MONTGOMERY COUNTY HISTORIC PRESERVATION COMMISSION
STAFF REPORT

Address:	3944 Baltimore Street, Kensington	Meeting Date:	3/23/2022
Resource:	Primary Resource Kensington Historic District	Report Date:	3/16/2022
Applicant:	Meredith Sharp	Public Notice:	3/9/2022
Review:	HAWP	Staff:	Dan Bruechert
Case Number:	897942 (Amended)	Tax Credit:	n/a
Proposal:	Revision – Building addition, fenestration, other details to previously approved HAWP.

The applicant proposes revisions to fenestration, stairs, the addition of skylights, and change in siding details on the building addition.

A006

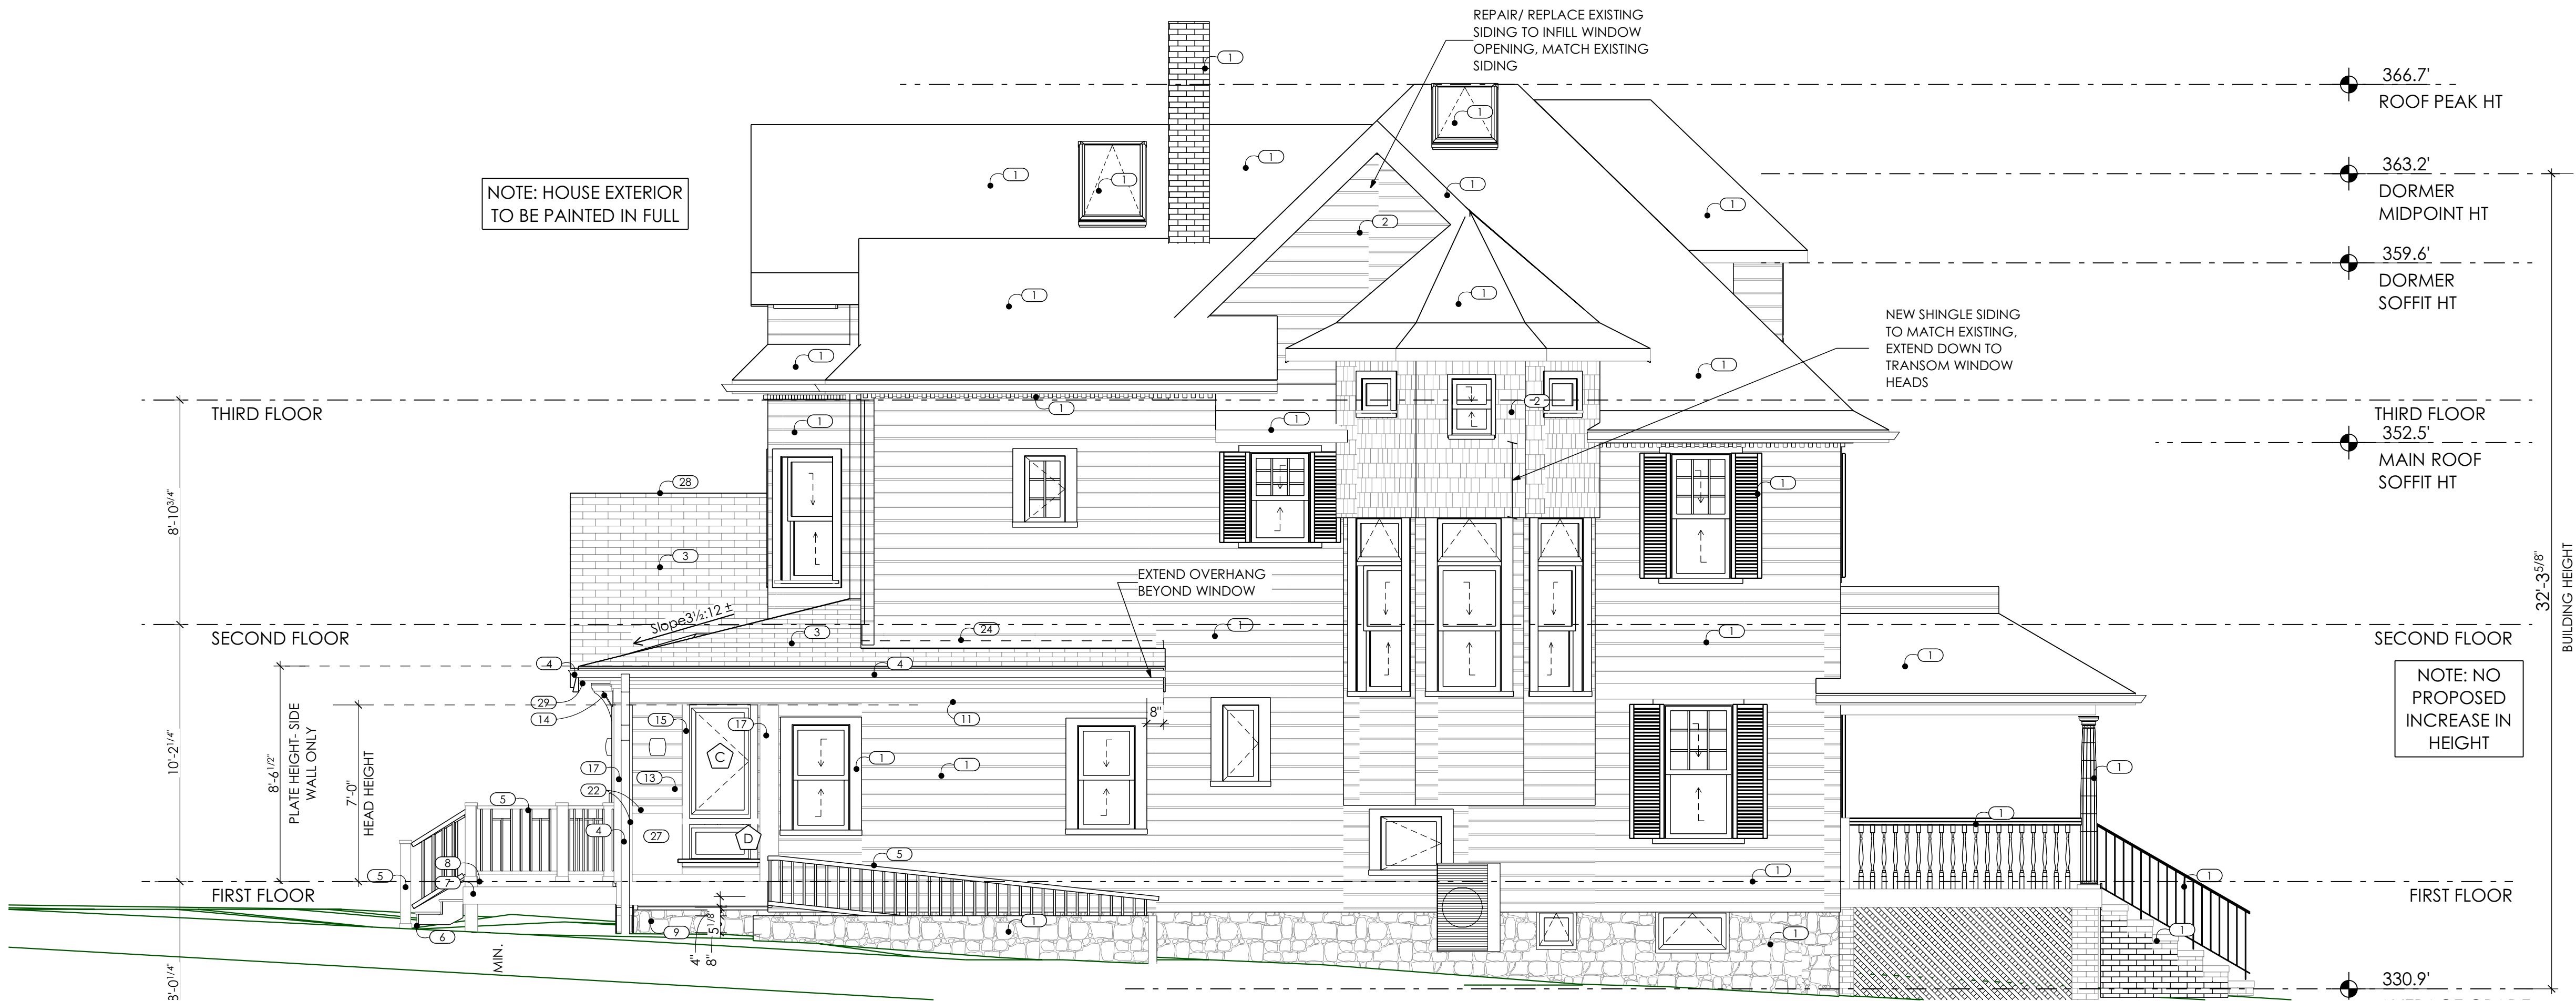
On the right elevation, the applicant proposes to change the fenestration in two locations. First, the applicant proposes to change a 6/1 sash window to a nine-lite casement. This change is minor and is consistent with the alteration proposed for the rear addition, discussed above. Staff finds this alteration will have a minimal impact on the character of the house or surrounding district and recommends approval.

The second change proposed on the right elevation is the fenestration on the first floor. Instead of the approved two fixed and two casement windows, the applicant proposes to install a pair of four-lite casement windows over smooth siding that will match the siding proposed for the rear. The clad wood windows will match the other windows approved for the rear of the house and due to its placement at the rear of the right elevation, the proposed window will not be visible from the public right-of-way. Staff finds these changes will not impact the character of the house or surrounding district and recommends the HPC approve the changes.
